**REHABILITATION OF THE MANSOUR
PUMP STATION**

SUSTAINMENT ASSESSMENT

**SIGIR PA-07-111
JANUARY 24, 2008**

SUBJECT: Report on the Rehabilitation of the Mansour Pump Station in the Al Amerea area of Baghdad, Iraq (Report Number SIGIR PA-07-111)

Site Photos 6 and 7. Dangerous installation connecting the vertical pump motor and the 100 mm submersible pump control panel.
 (Photos courtesy of USACE)

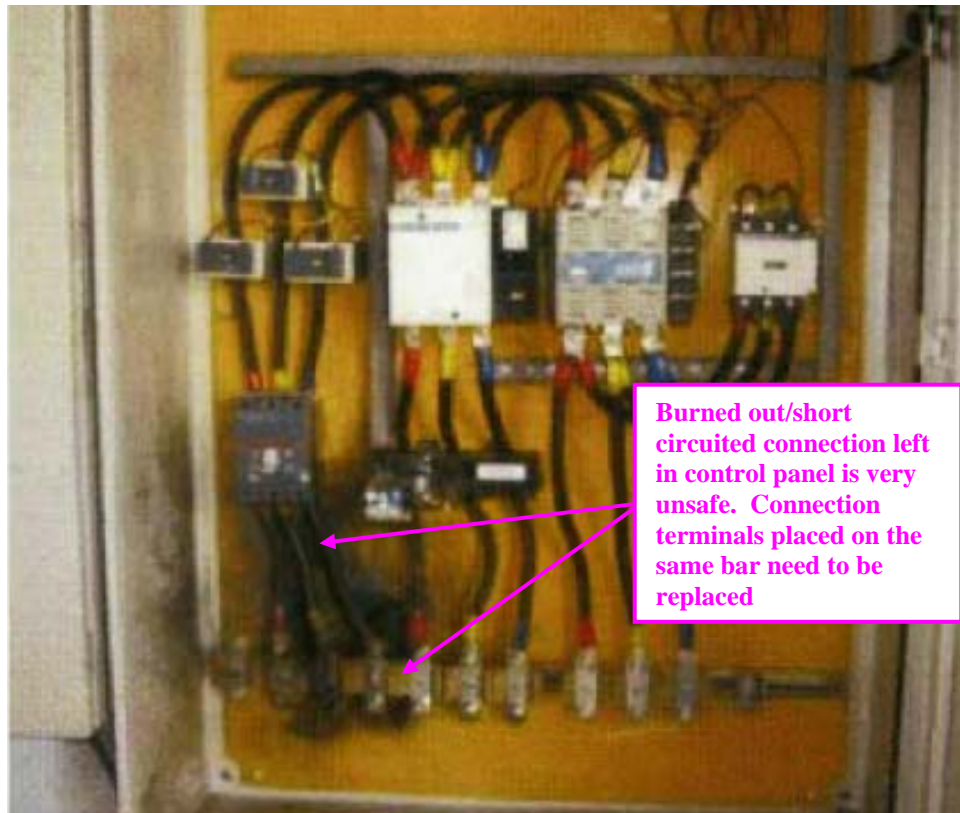
A review of the photographs taken during the final inspection provides insight into the installation techniques and practices employed by the Phase 3 contractor. For example, the contractor used very poor and potentially dangerous installation techniques while attempting to connect a vertical pump motor (Site Photo 6) and the 100 mm submersible pump control panel (Site Photo 7). Finally, the USACE representative performing the final inspection had to point out that an electrical fire within the 300 mm vertical pump control panel necessitated repair of the control panel (Site Photo 8). The electrical fire is evidence of poor installation techniques used by the contractor.

Site Photo 8. Electrical fire within the 300 mm vertical pump control panel.
 (Photo courtesy of USACE)

Site Photo 15. Installation of the 15m galvanized pump by the contractor. (Photo courtesy of USACE)

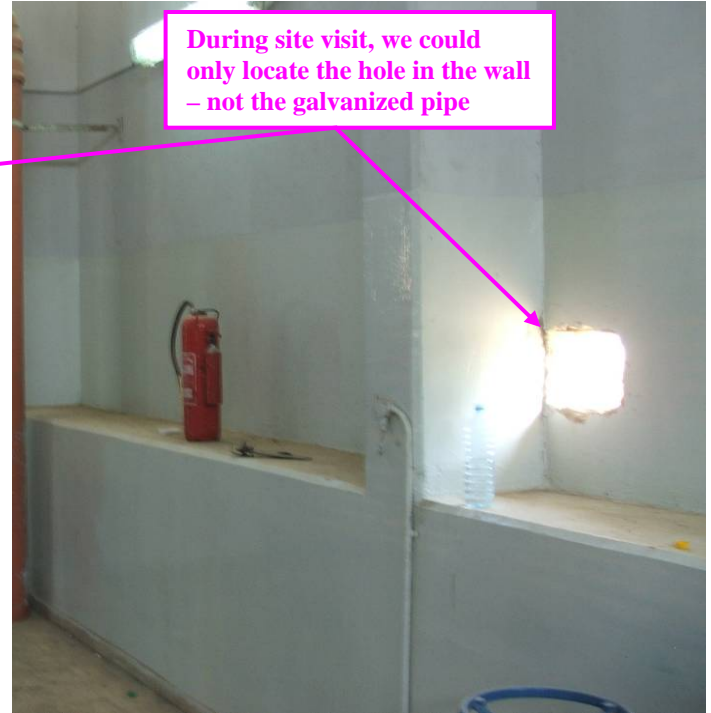
During our site visits, we first noticed that the galvanized pipe for the submersible pump that was installed by the contractor had been removed (Site Photos 15 and 16).

Site Photo 16. Location of where the 15m of galvanized pump and the 100mm submersible pump should be.

Site Photo 19. Rust indicates that the 350 mm vertical pump is either not new or not properly installed

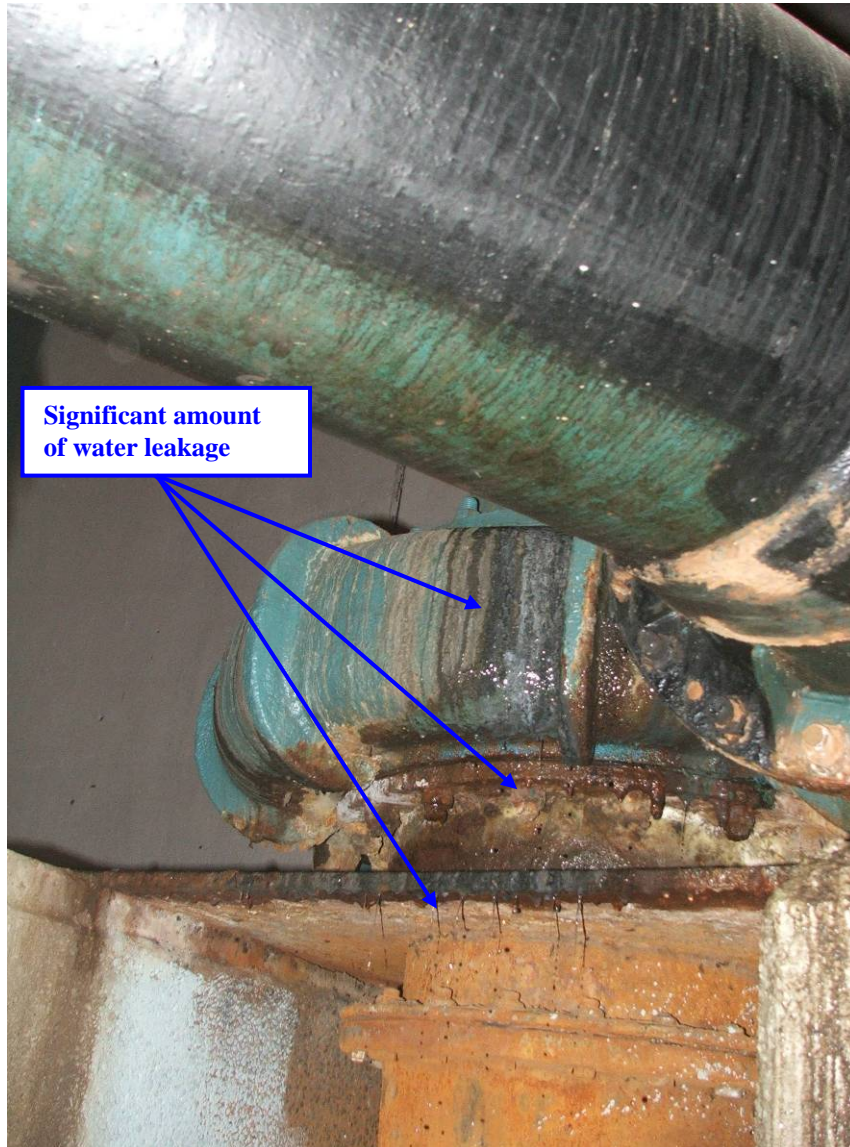
A new vertical pump should not suffer from water leaks

Significant amount of rust and corrosion for an 8 month old vertical pump

Site Photo 20. Significant water leaking witnessed from the 350 mm vertical pump

Site Photo 22. View of the condition of 800 mm vertical pump installed by the contractor (Photo courtesy of the USACE)

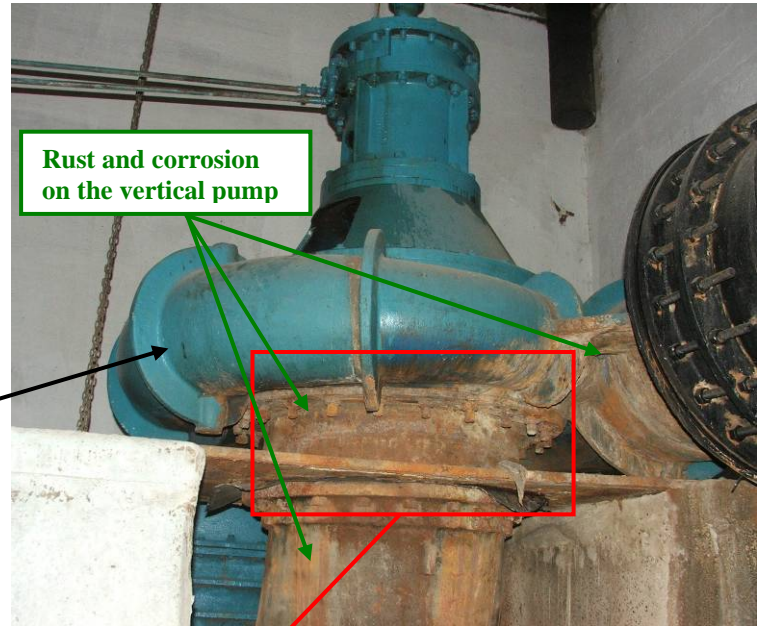
Without any contract file documentation to determine the condition of the vertical pumps prior to installation, we closely reviewed the vertical pumps from the QAR photographs. All we could determine was that, while sometimes cosmetically damaged, the vertical pumps appeared to be in relatively good condition (i.e. no rust or holes) (Site Photo 22).

During our site visits, we identified significant amounts of rust on the bottom of all four vertical pumps and the nuts and bolts connecting the vertical pumps to the outlet pipes. For example, in the case of the 800 mm vertical pump, the bottom of the pump is severely rusted as well as the nuts and bolts connecting it to the outlet pipe (Site Photos 23 and 24). There are only two possible reasons to explain the significant amount of rust on the bottom of the newly installed vertical pumps – either the pumps installed were used (and previously rusted) or the contractor did not properly install the vertical pumps. Poor installation of the vertical pumps would result in water overflowing the pump causing rust to form.

Site Photo 23. View of rust SIGIR Inspectors witnessed on the same vertical pump

Site Photo 25. View of the 600 mm vertical pump

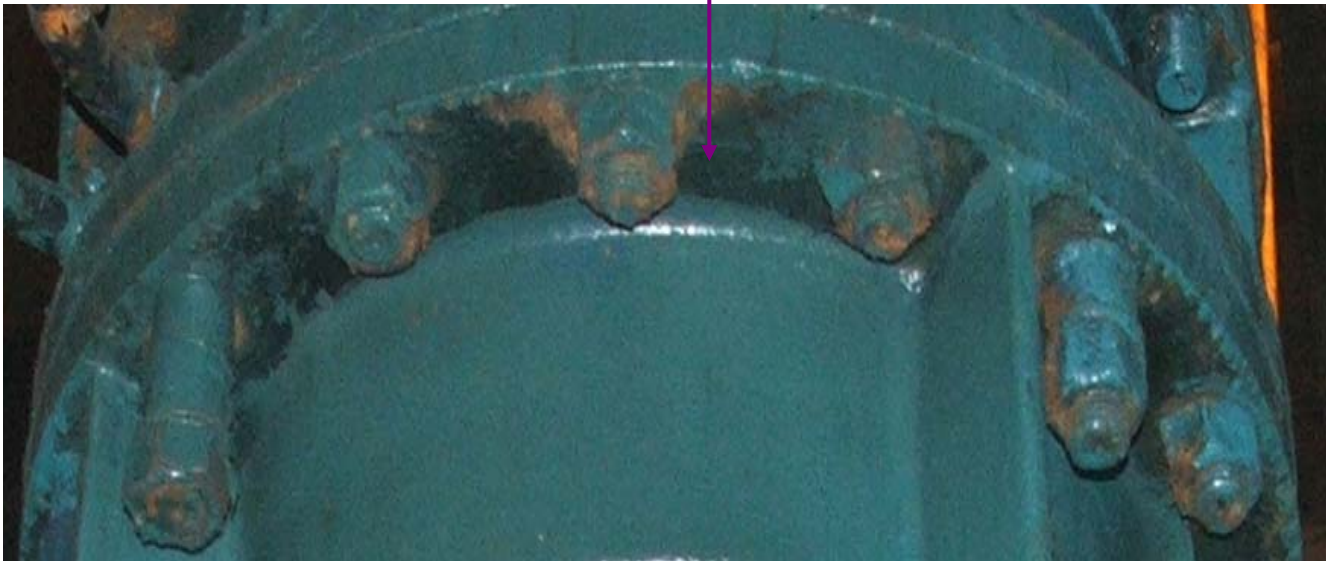
For the 600 mm vertical pump, we also witnessed a significant amount of rust for a pump that was installed in January 2006. The Phase 4 contract required the painting of the vertical pump; however, the excessive amounts of rust are visible through the paint, especially around the nuts and bolts and the shaft areas (Site Photos 25 and 26).

Site Photo 29. View of the vertical pumps within the pump station dry well

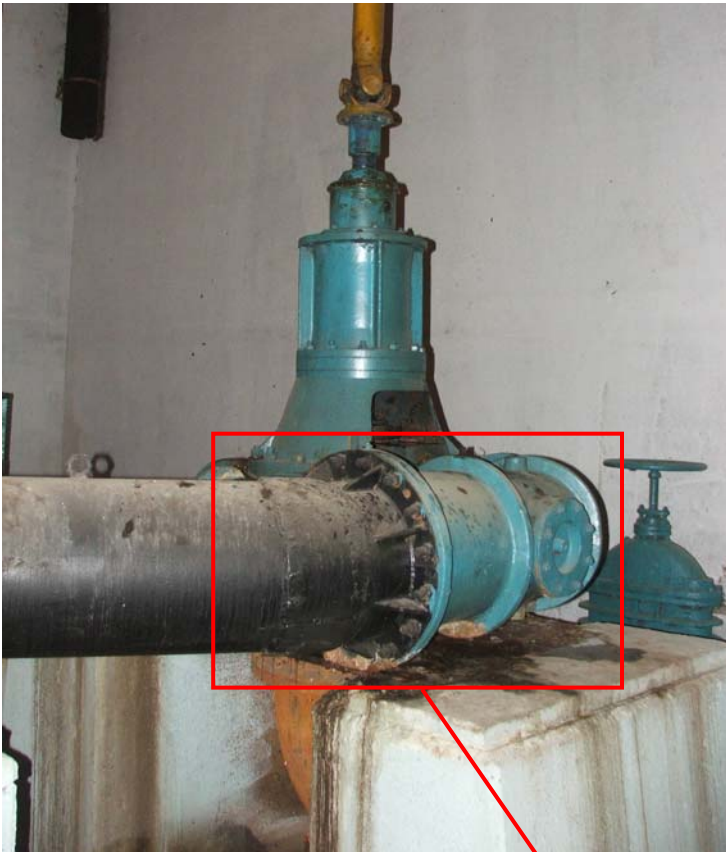
During our site visits, we identified the replacement of only the 800 mm vertical pump gate valve (Site Photo 29). The replacement gate valve is a different shape and size than the pre-existing gate valves, which required the contractor to reconfigure the connection with the outlet pipe from the vertical pump. According to the Phase 4 contractor, the original gate valve collapsed as a result of years of rust and corrosion (Site Photo 30).

Site Photo 30. View of the original gate valve for the 800 mm vertical pump

Site Photo 31. View of 350 mm vertical pump gate valve

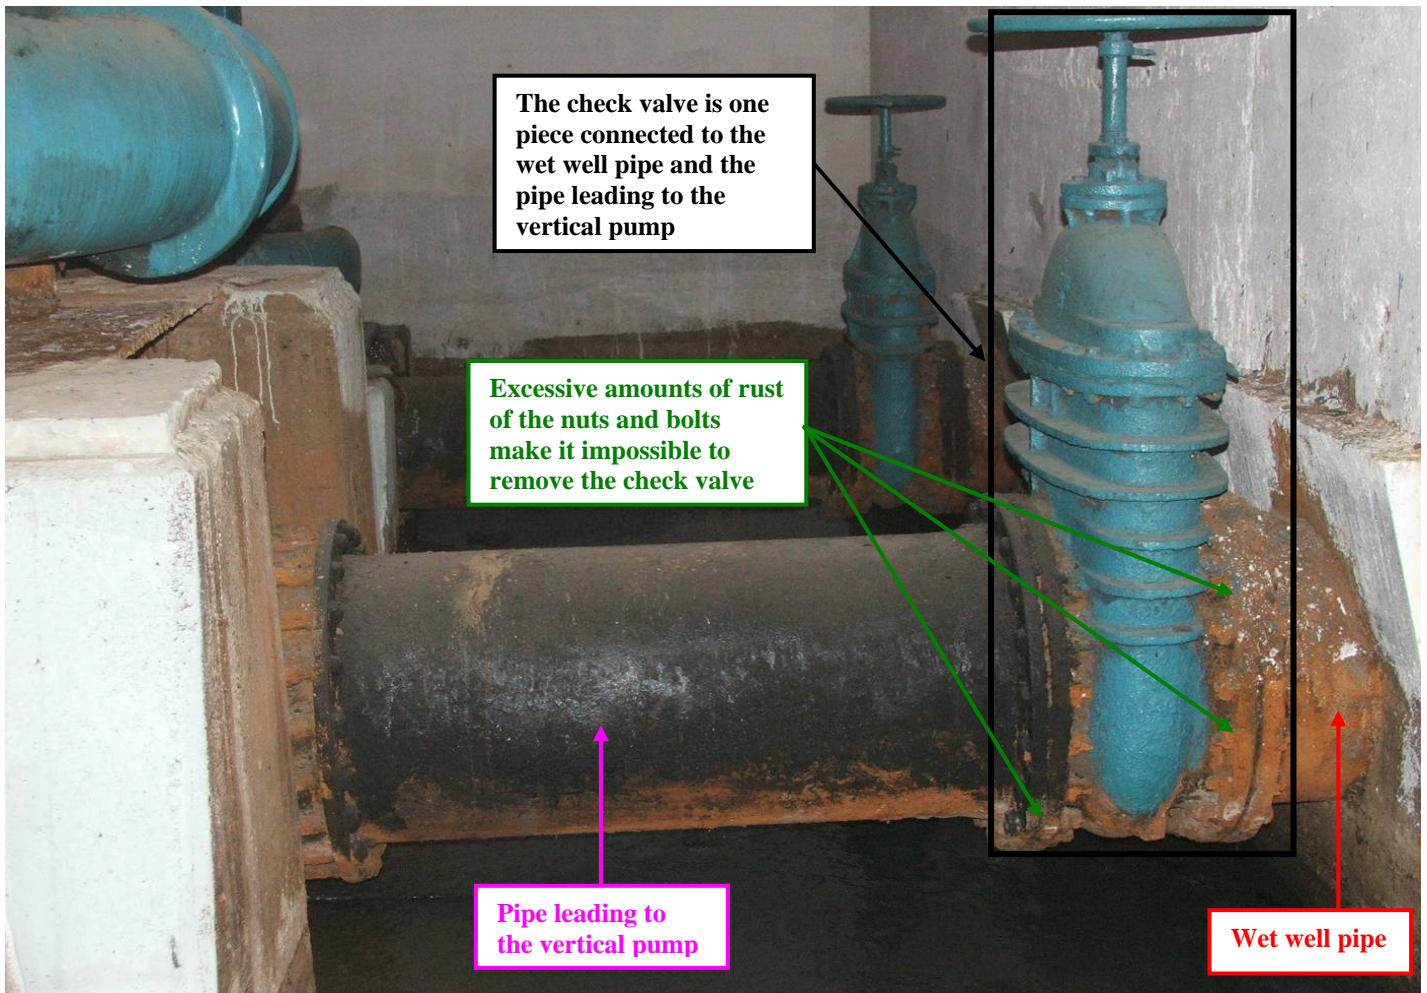
To make the determination of whether to repair or replace a vertical pump gate valve required the contractor to remove the gate valve and inspect it to see if significant rust and corrosion were present and also determine the quality of the nuts and bolts. We saw no evidence that the contractor attempted to remove the gate valves for the 350 mm, 500 mm, and 600 mm vertical pumps. For example, several nuts and bolts to the 350 mm vertical pump gate valve were so rusted that it would be impossible to remove them without cutting them off (Site Photos 31 and 32). The only work performed by the contractor for these three vertical pump gate valves was painting.

As with the gate valves, the rehabilitation of check valves would require the contractor to remove each one to determine if significant rust and corrosion were present. For the check valves, we also saw no evidence that the contractor did anything except paint over the rust on the existing valves. For example, the 350 mm and 500 mm vertical pump check valves are so significantly rusted onto the inlet and outlet pipes that there is no possible way it could have been removed and inspected (Site Photo 33). It appears the contractor only painted over the rust on the pre-existing check valves.

Site Photo 32. Close up view of Site Photo 31

Site Photo 33. View of the check valves for the 350 mm and 500 mm vertical pumps

Site Photo 35. Location of the pump station fuel tank

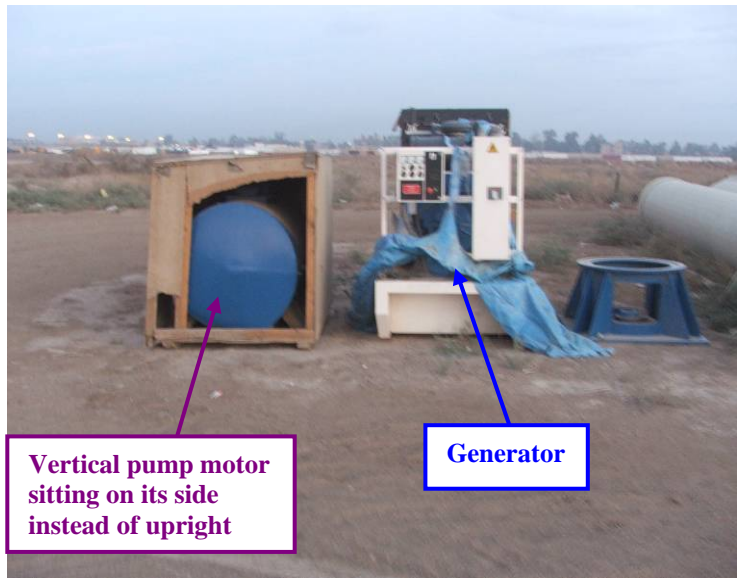
“The fuel tank concrete base have been poured today, the location of the fuel tank was not according to the submitted plans location or according to the BOQ [Bill of Quantities] location (in the BOQ the location specified in the middle of the two generators), also the distance between the fuel tank location & the 750 KVA generator new location less than 2.8 m, fire rated wall may need to construct between the fuel tank & the generator.”

During the site visits, we identified the fuel tank and determined that it was still not located between the two generators and a fire rated wall was not constructed between it and the 750 kVA generator (Site Photo 35). Even though the daily QA report identified an instance when the contractor did not perform according to the contract's requirements, no action was taken against the contractor by the USACE. Consequently, the fuel tank is not located centrally between the two generators and continues to pose a potential fire hazard for the pump station.
